Date: April 29, 2024

Project/File: **Pointe Pierce Villas Subdivision / GCPP24-0002 / SUBFY2024-0002**
This is a preliminary and final plat application for the development of a 17-unit multifamily development and 8-unit townhouse on 0.83-acres.

Lead Agency: Garden City

Site address: 405 & 409 E 47th Street

Site Plan

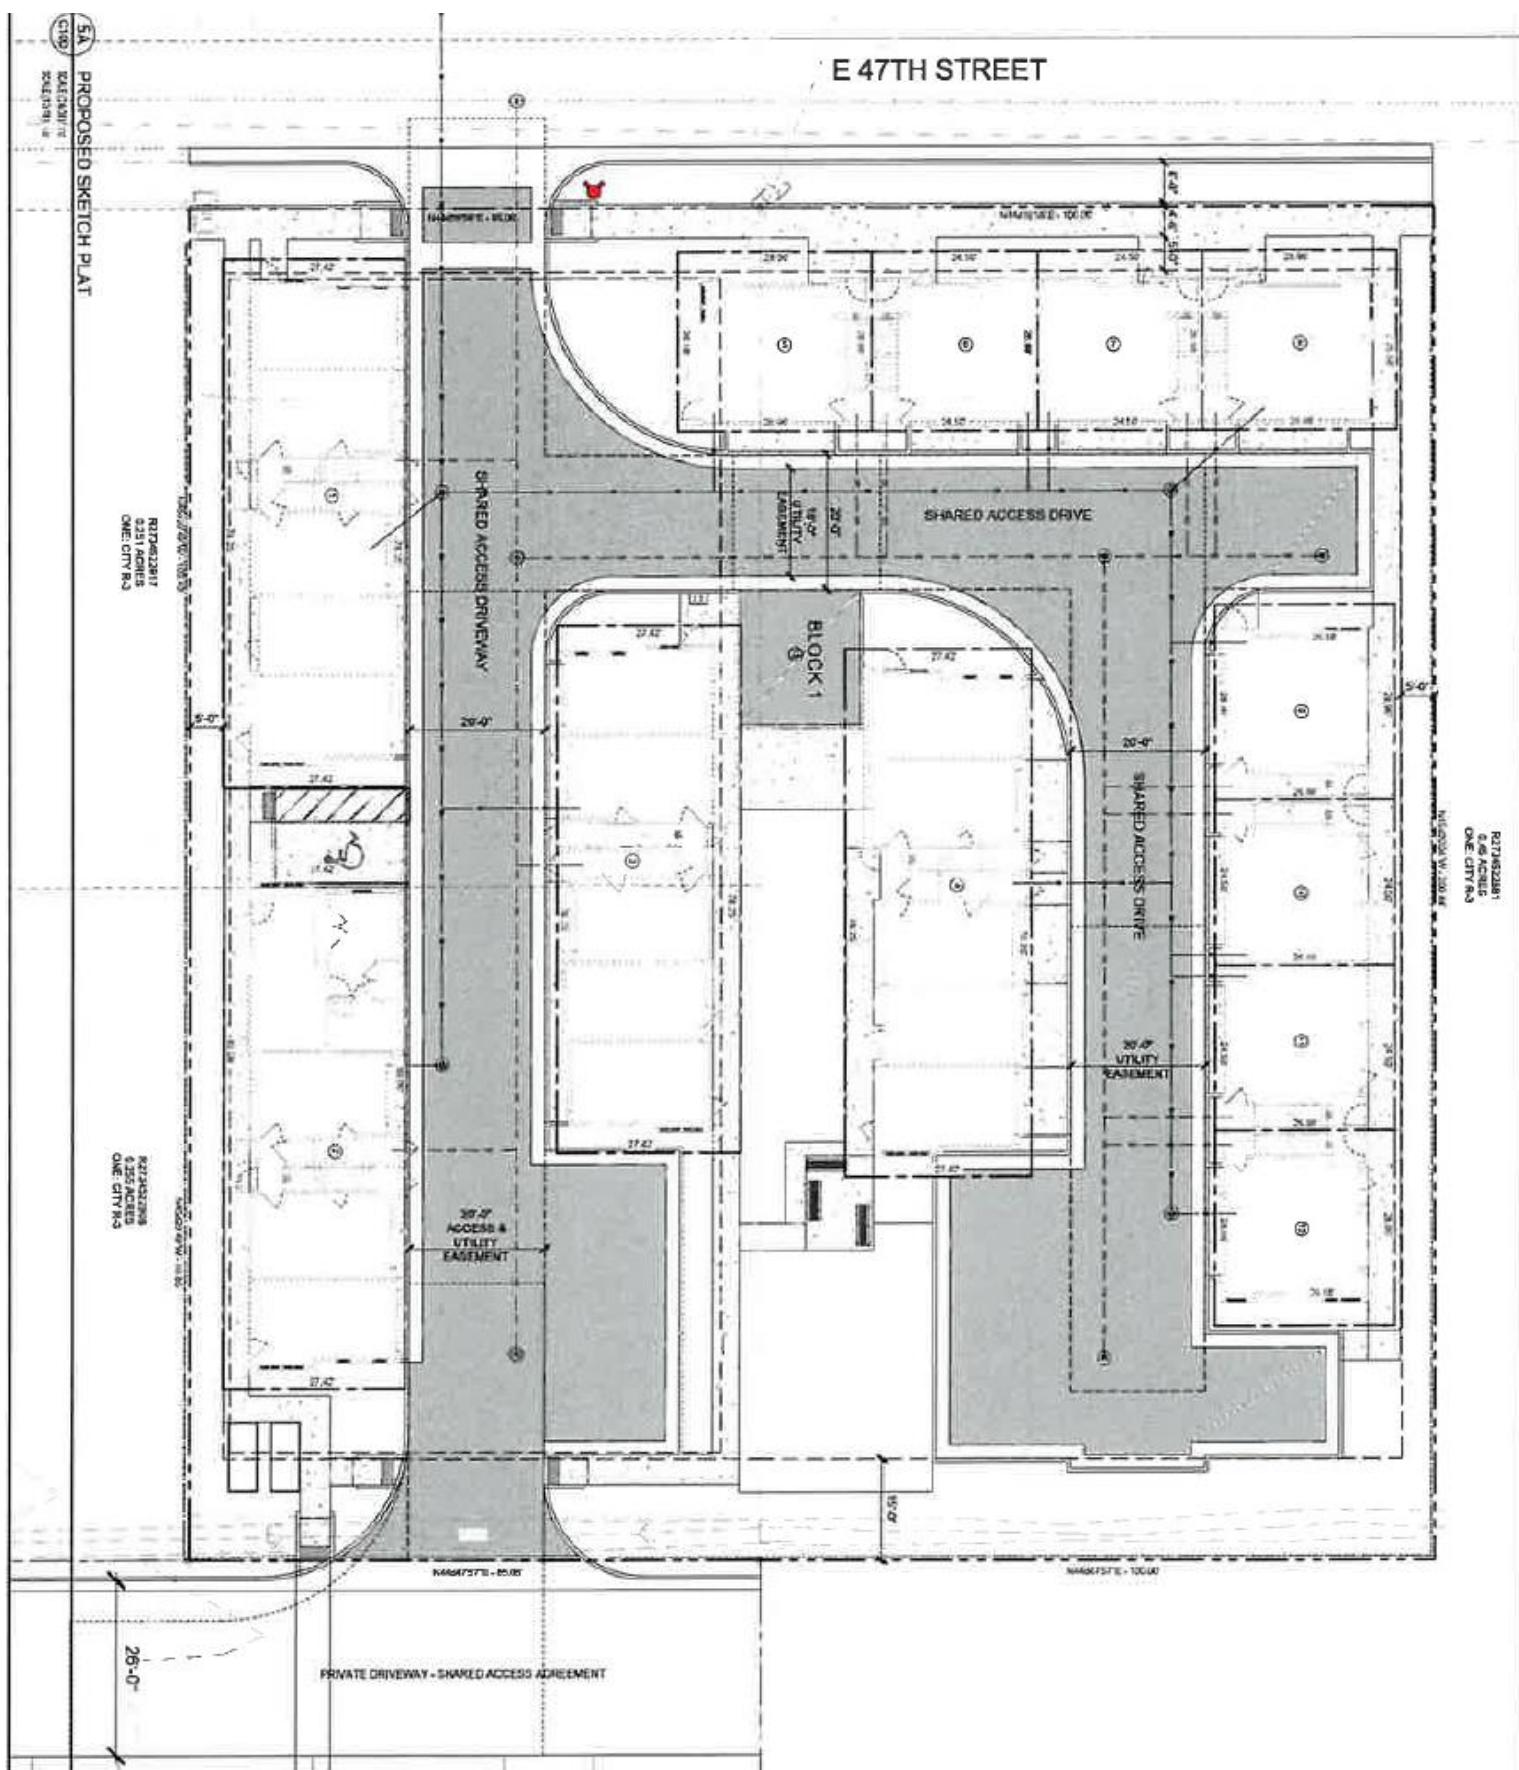
1. Construct 47th Street as ½ of a 36-foot commercial street section with curb, gutter, an 8-foot wide planter strip, and 5-foot wide detached sidewalk.

2. Provide a permanent right-of-way easement from 2-feet behind back of curb to 2-feet behind back of sidewalk.
3. Close the existing 73-foot wide paved driveway on 47th Street located 177-feet east of Adams Street and 10-foot wide unimproved driveway on 47th Street 286-feet east of Adams Street driveways with curb, gutter, and 5-foot wide sidewalk.

4. Construct a 20-foot wide shared access curb-return type driveway located 181-feet east of Adams Street.
5. Submit civil plans to ACHD Development Services for review and approval. The impact fee assessment will not be released until the civil plans are approved by ACHD.

- a. Existing Conditions:** 47th Street is improved with 2-travel lanes and no curb, gutter or sidewalk abutting the site. There is 50-feet of right-of-way for 47th Street (24-feet from centerline).
- b. Applicant's Proposal:** The applicant is proposing to construct 47th Street as $\frac{1}{2}$ of a 36-foot wide commercial street section with curb, gutter, a 6-foot wide planter strip, and 5-foot wide detached concrete sidewalk.
- c. Staff Comments/Recommendations:** The applicant's proposal to construct 47th Street as $\frac{1}{2}$ of a 36-foot commercial street section with curb, gutter, and 5-foot wide detached sidewalk exceeds District policy and should be approved, as proposed. For the installation of trees, the applicant should be required to construct the planter strip to a minimum of 8-feet wide.

- a. Existing Conditions:** There is an existing 73-foot wide paved driveway on 47th Street located 177-feet east of Adams Street and 10-foot wide unimproved driveway on 47th Street 286-feet east of Adams Street (measured centerline to centerline).
- b. Applicant's Proposal:** The applicant is proposing to close the existing driveways with curb, gutter, and 5-foot wide sidewalk. The applicant is proposing to construct a 20-foot wide shared access curb-return type driveway located 181-feet east of Adams Street (measured centerline to centerline).
- c. Staff Comments/Recommendations:** The applicant's proposal meets District policy and should be approved, as proposed.
